EAGLE RIDGE PRD AMENDMENT

PHASE 2

JOB NUMBER: 07.1380.001
 DATE: 12/26/08

REVISIONS	TITLE

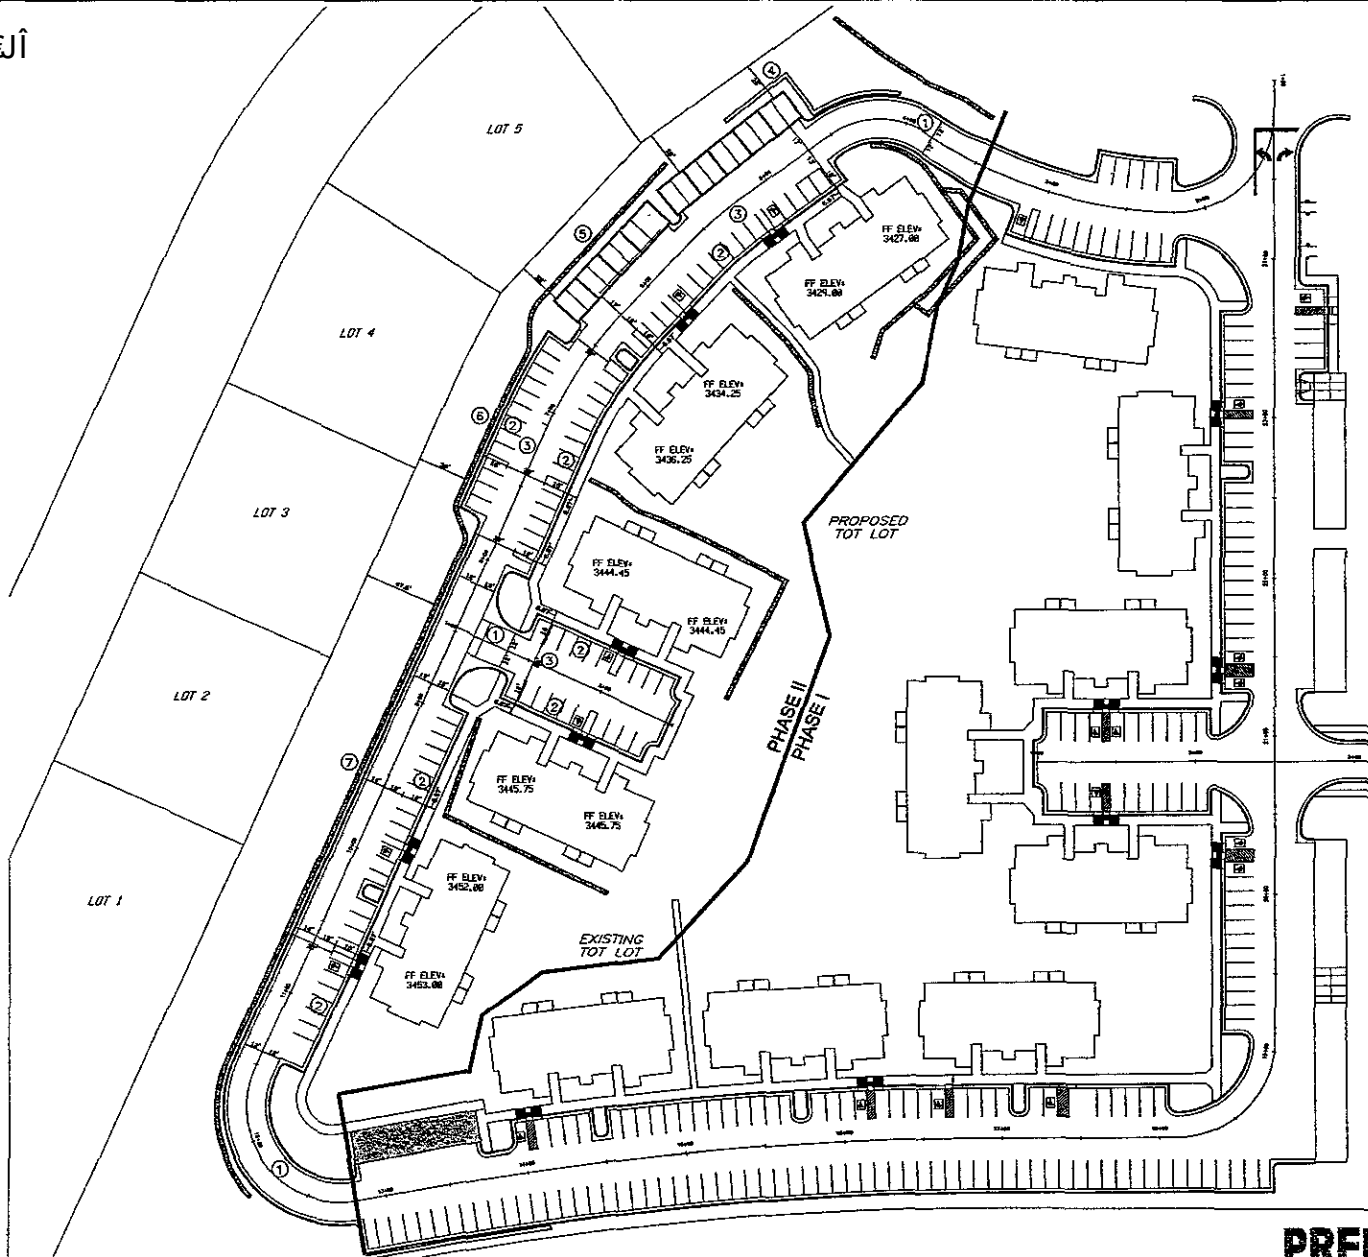
PROPOSED REVISIONS:

- ① LAND WIDTH CHANGE FROM 13.5' TO 12' WIDE.
- ② PARKING LANE CHANGE 18' TO 16'.
- ③ 26' WIDE ACCESS AISLE MAINTAINED.
- ④ RETAINING WALL MOVED ADDITIONAL 11.5' AWAY FROM PROPERTY LINE.
- ⑤ RETAINING WALL MOVED ADDITIONAL 12.5' AWAY FROM PROPERTY LINE.
- ⑥ RETAINING WALL MOVED ADDITIONAL 9' AWAY FROM PROPERTY LINE.
- ⑦ RETAINING WALL MOVED ADDITIONAL 6' AWAY FROM PROPERTY LINE.
